Service Bulletin

RRP Service Bulletin No: RRP SB339

Title: Push Tool Replacement (RRP# 793040)

Product Series: Advance Tie Plate Inserter [ATPI]

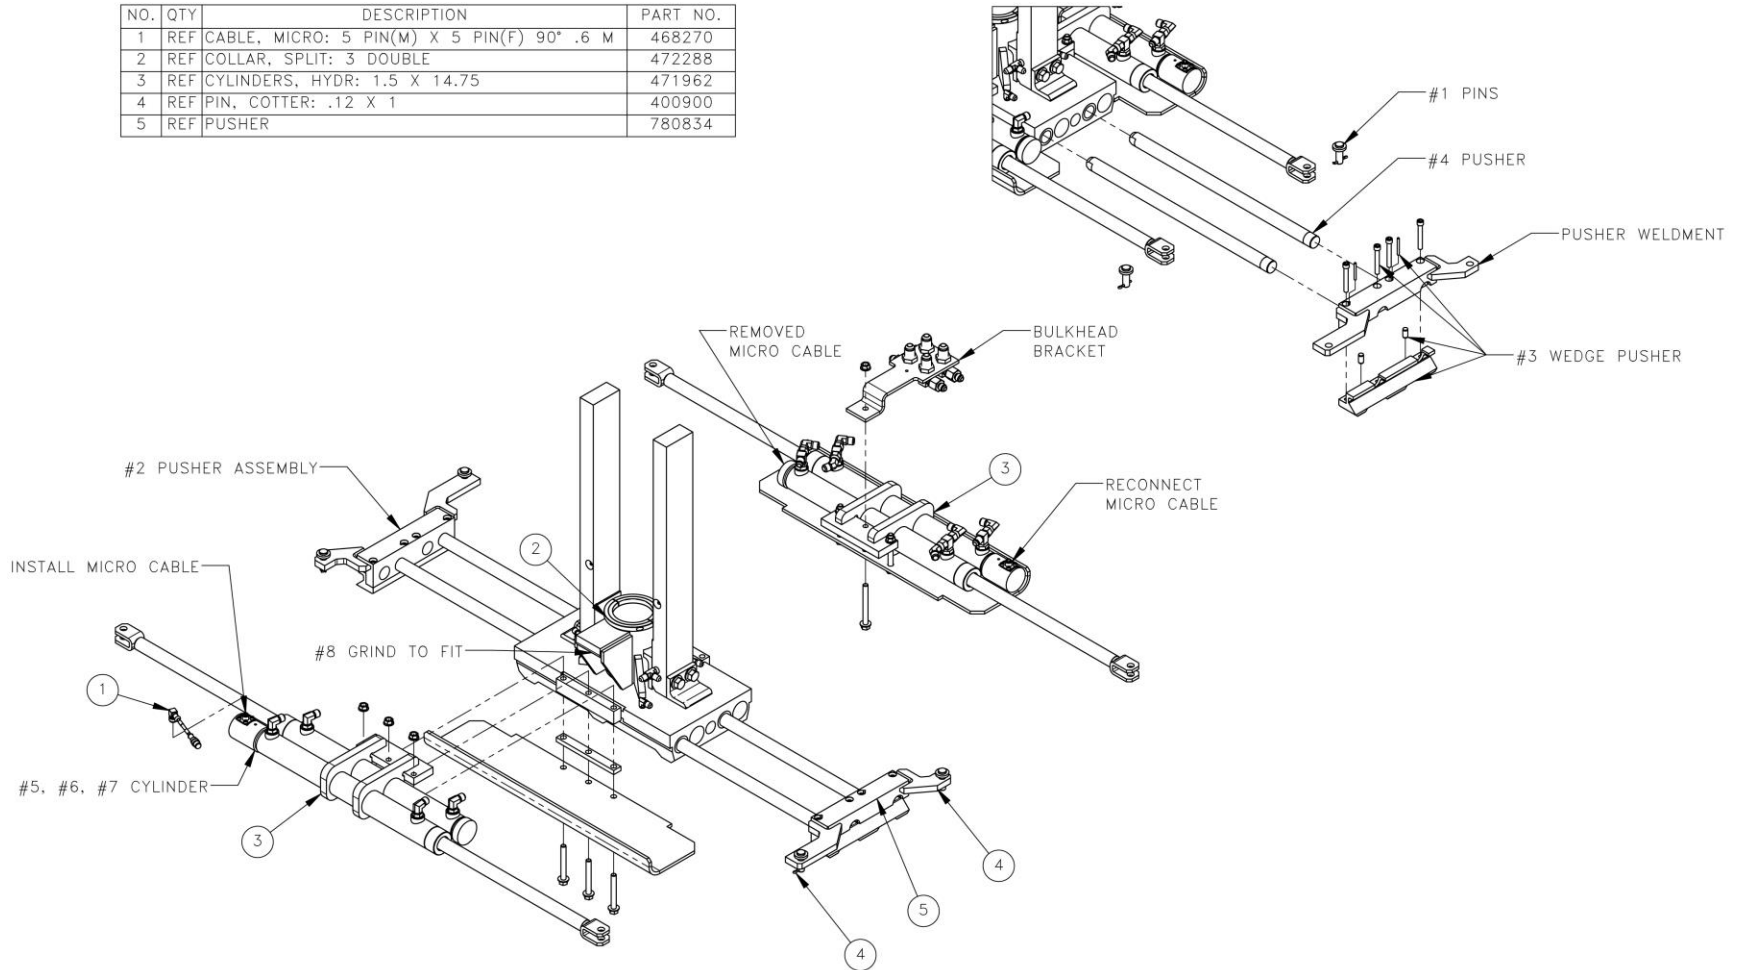
Summary: The previous Push Tool assembly interfered with the tie plate inserter operation. The Push Tool replacement corrects this issue.

8. Install split collar onto the large hydraulic cylinder before raising assembly. It may be necessary to grind the bottom of latch plate to allow latching when assembly is raised, do not grind latch hook.

Note: During reassembly of the hydraulic cylinders onto the center jack foot, the micro-cable that was connect to the left-hand center jack insert cylinder most rearward needs to be moved and reconnected to the forward left-hand insert cylinder that was previously not connected.

1. Remove the cotter pin, clevis pin and washers from each cylinder (4) places.
2. Remove the Pusher Tool Assembly (2) places.
3. Remove the screws, roll and dowel pins from the push tools to remove the wedge pushers.

4. Remove the rods from each Push Tool Assembly.
 - Return the pusher weldments to Racine Railroad Products.
 - Install removed guide rods and wedge pusher on supplied weldment. Note: Be sure to install roll pins.

- Apply Primer T and Loctite 242 onto each rod before installing the rods onto the supplied Push Tool weldment.
5. Disconnect hydraulic hoses and cables from the cylinders, **take note of what cable go to the left and right so they can be correctly reconnected.** After disconnecting the cables from each existing cylinder, remove the hardware, guard, spacer and hydraulic cylinder.

6. Remove all fittings from the cylinders and remove the bulkhead bracket on the opposite end.
 - Return the hydraulic cylinders to Racine Railroad Products.

7. Install the supplied cylinders, pushers and cotter pin in the reverse order, connect hoses and cables to the correct cylinders and verify connections before testing.
